UNITED STATES PATENT AND TRADEMARK OFFICE

APPLICATION NO.	FILING DATE	FIRST NAMED INVENTOR	ATTORNEY DOCKET NO.	CONFIRMATION NO.
10/528,424	03/18/2005	Masatoshi Hada	05021	4913

Office Action Summary	Application No. 10/528,424	Applicant(s) HADA ET AL.	
	Examiner Vinh T. Luong	Art Unit 3682

Fig. 1

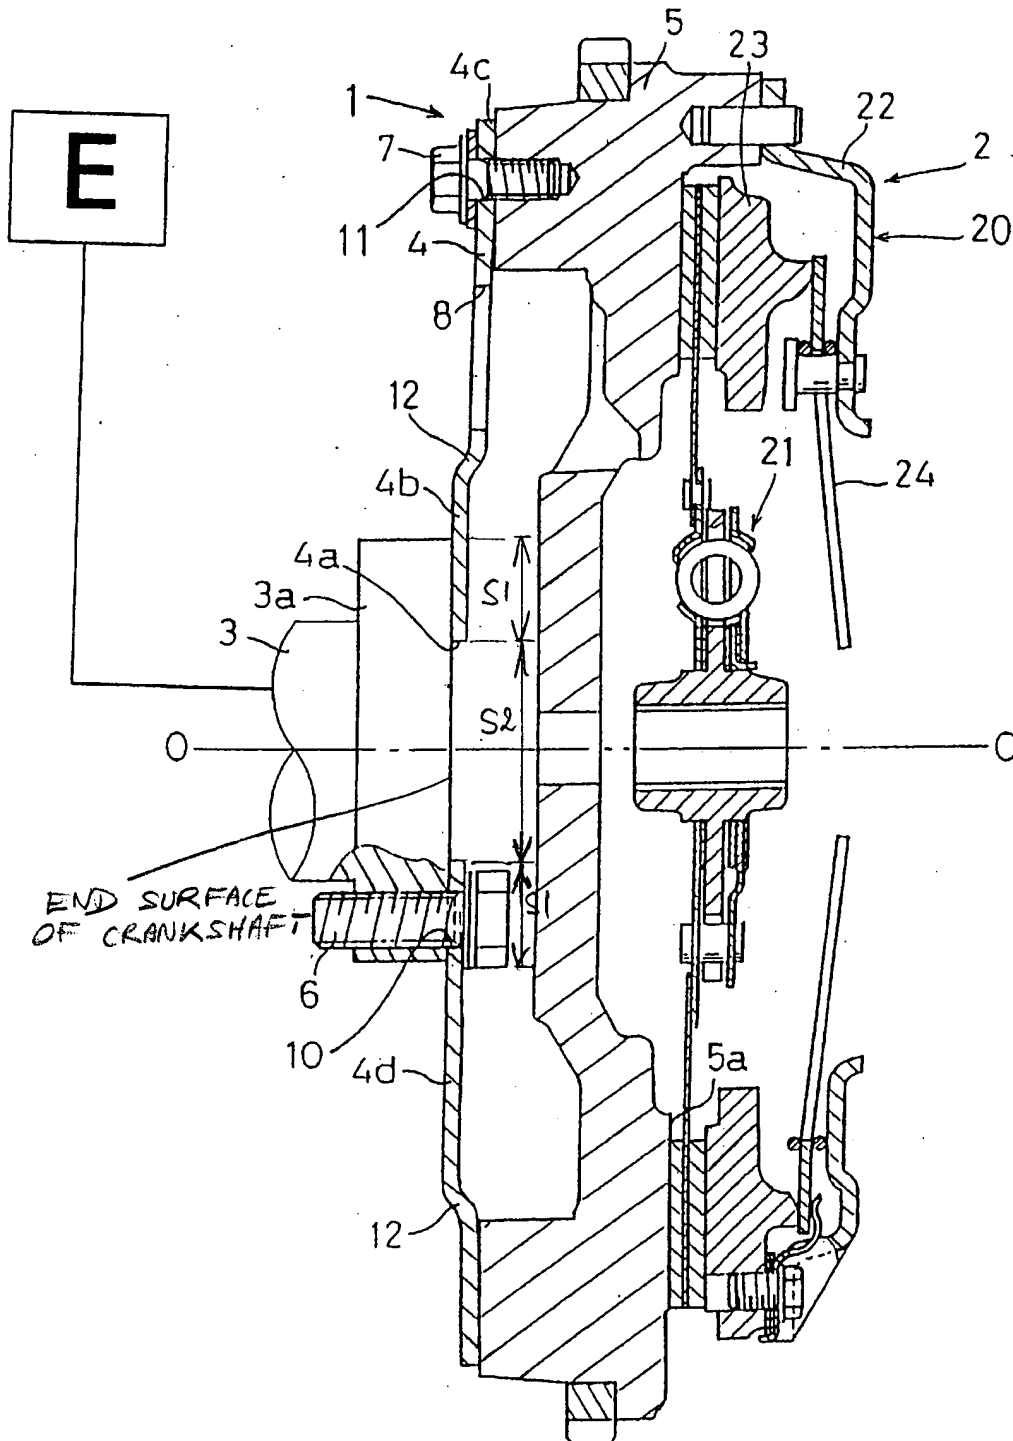
Regarding claim 1, Doman teaches a flywheel 1 in which a central part 4b, 4d of a thin plate portion 4 having a flywheel mass 5 provided on an outer peripheral side of the plate portion 4 is joined to an end surface (unnumbered. See Attachment or "Att.") of a crankshaft 3, 3a through a plurality of bolts 6 disposed annularly at intervals (Fig. 2), characterized in that, within a contact zone (S1 in Figs. 1 and 2 of Att.) of a substantially polygon (Fig. 3 of Att.) defined by

linking each center of the bolts 6 with straight lines excluding the bearing surfaces of the bolts 6, the plate portion 4 has a non-contacting part (S2 in Figs. 1 and 2 of Att.) set not to contact with the end surface of the crankshaft 3, 3a, and the area of the non-contacting part (S2) is set to be a determined percentage of the whole area of the contact zone (S1).

Regarding claim 3, the plate portion 30 is provided with a non-contacting part (at 31a in Fig. 4 of Att.) that does not contact with the end surface (Fig. 1 of Att.) of the crankshaft 3, 3a.

Fig. 3

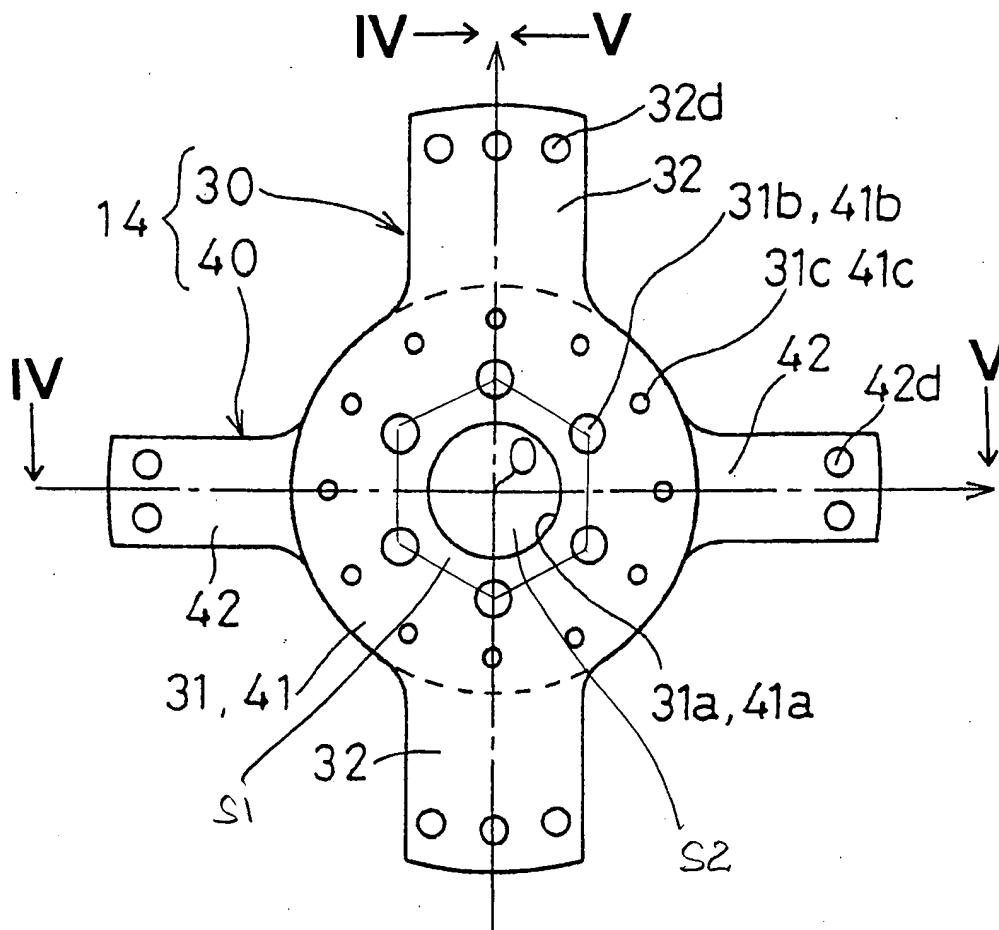
Regarding claim 2, Doman teaches a flywheel 1 in which a central part 31 (Figs. 3-5. See column 5, line 54+) of a thin plate portion 30 having a flywheel mass 5 (Fig. 1) provided on an outer peripheral side of the plate portion 30 is clamped between a reinforcement 40 and an end surface of a crank shaft 3, 3a (Fig. 1, Att.) and is joined thereto through a plurality of bolts 6 disposed annularly at intervals, characterized in that, within a contact zone (S1 in Fig. 3 of Att.) of a substantially polygon (Fig. 3, Att.) defined by linking each center of the bolts 6 with straight lines excluding the bearing surfaces of the bolts 6, the reinforcement 40 has a non-contacting part

(S2 in Figs. 3 and 4 of Att.) set not to contact with the plate portion 30, and the area of the non-contacting part (S2) is set to be a determined percentage of the whole area of the contact zone.
